**Lead Local Flood Authority**

**RE: DC/25/1019 – Land To The West of Shoreham Road Small Dole West Sussex**

This is an outline planning application for up to 45 dwellings (including affordable homes) with all matters reserved apart from access.

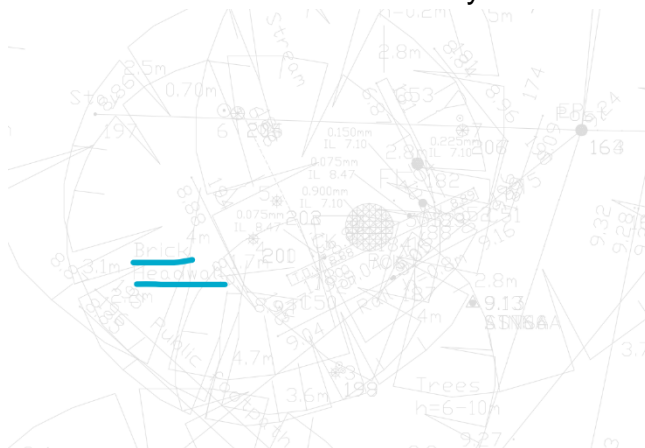
- 1) The topographic survey provided is not clear for the watercourse along the southern boundary of the site, which it is proposed to discharge to (see below example). We require a more comprehensive topographic survey with top of bank and bed levels. Please ensure any existing and proposed structures are clearly marked with invert levels and pipe diameters. In particular, this should include the culvert(s) immediately upstream to the East and the proposed outfall headwall. This will enable us to ensure a gravity connection from the site is feasible and to assess flood risk more accurately.
